Title - Sujet Steveston Paramount Wharf 403 Recon Reconstruction du quai 403 de Steveston Paramount	
Solicitation No. - N° de l'invitation F1571-210984/A	Amendment No. - N° modif. 009
Client Reference No. - N° de référence du client F1571-210984	Date 2022-01-27
GETS Reference No. - N° de référence de SEAG PW-\$PWY-028-9095	
File No. - N° de dossier PWY-1-44142 (028)	CCC No./N° CCC - FMS No./N° VME
Solicitation Closes - L'invitation prend fin at - à 02:00 PM Pacific Standard Time PST on - le 2022-02-01 Heure Normale du Pacifique HNP	
F.O.B. - F.A.B. Plant-Usine: <input type="checkbox"/> Destination: <input checked="" type="checkbox"/> Other-Autre: <input type="checkbox"/>	
Address Enquiries to: - Adresser toutes questions à: Lam (PWY), Tian	Buyer Id - Id de l'acheteur pwy028
Telephone No. - N° de téléphone (604) 363-7968 ()	FAX No. - N° de FAX () -
Destination - of Goods, Services, and Construction: Destination - des biens, services et construction: DFO – Steveston Paramount Wharf 403 – Richmond, BC

The Solicitation Amendment 009 is raised to issue Addendum 006.

Amendment to Section 31 62 17 clause 2.1 SHEET PILES

Q1. Extent of Timber Decking

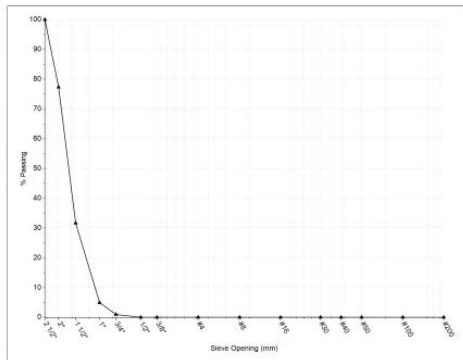
Amendment 3, Addendum 2 and Amendment 5, Addendum 3 indicate the timber decking within the footprint of the building will be removed by others. Does this include stringers as well?

A1: No, it does not.
